SERVICE LETTER SL20 65-45100 Rev B

Part/Assembly #: 65-45100

Float Model Affected: Aerocet Model 6650 Floats, Kodiak Aircraft

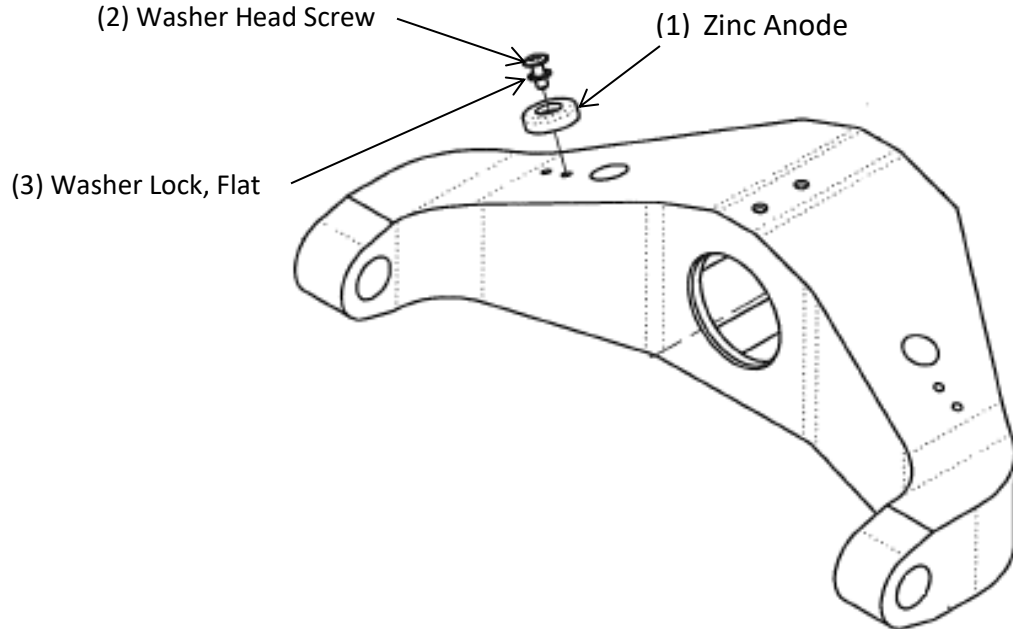
Reason for Change: To Increase anodic protections in the 6650 float gear.

1. Add optional installation of 35A-40120 Zinc Anode to unused, inboard #10-32 threaded hole.

2. Assure continuity between anode and assembly.
3. Chase threads if necessary to remove possible insulating debris or anodizing
4. Recommend filling the remaining, unused #10-32 outboard hole with Sika-Flex 292 or equivalent marine grade urethane sealant.
5. Apply Loctite Thread blocker Blue 242 to #10 fasteners upon installation.
